Range <b>H&amp;C</b>	Model <b>9100</b>	N° T.I. <b>09_2016</b>
Serial Number <b>63911533</b>	Subject <b>NEW CUP SUPPORT DESIGN</b>

# TECHNICAL INFORMATION JDE

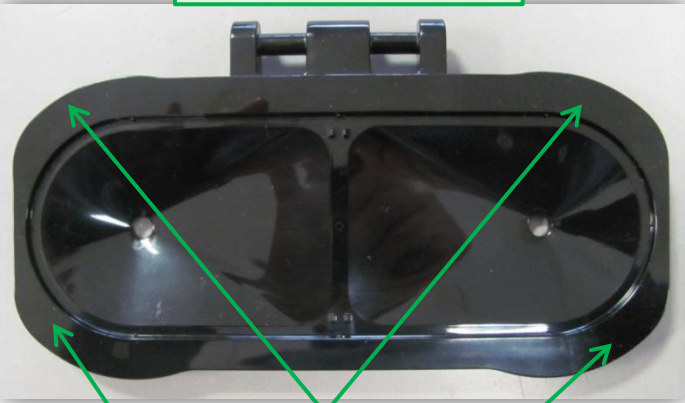
With the aim to improve our equipment, starting from S/N **63911533**, the **cup support** has been modified:

- the **support surface has been increased** in order to house a bigger cup (till diameter 85 mm)
- the following features have been improved:
  - the *cup support coupling* with the *flap hinge*
  - the *cup support stiffness*.

Support surface increased

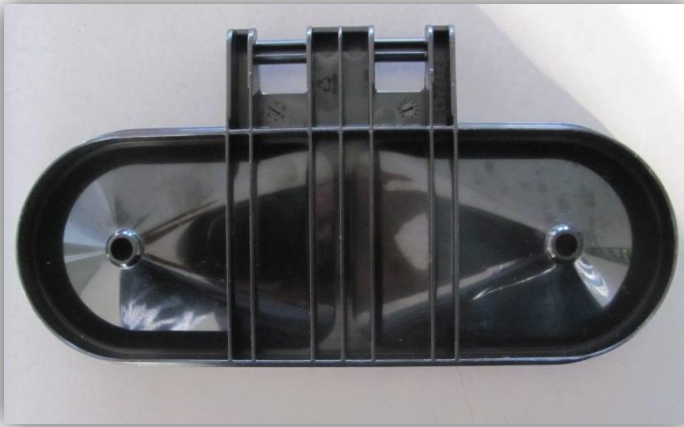
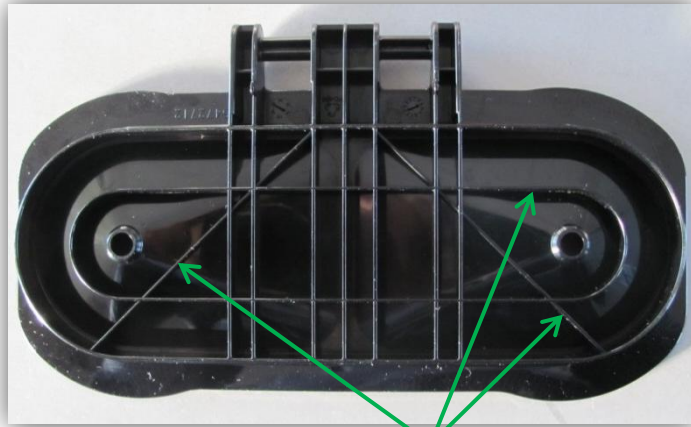
**Diameter** dimension reduced in order to improve the *Cup support* coupling with the *support hinge*

Cup support stiffness increased thanks to **new ribs**.

For machines previous to S/N above it's possible to mount the *new Cup support*.

The **cup support** spare code is not changed: **259736**
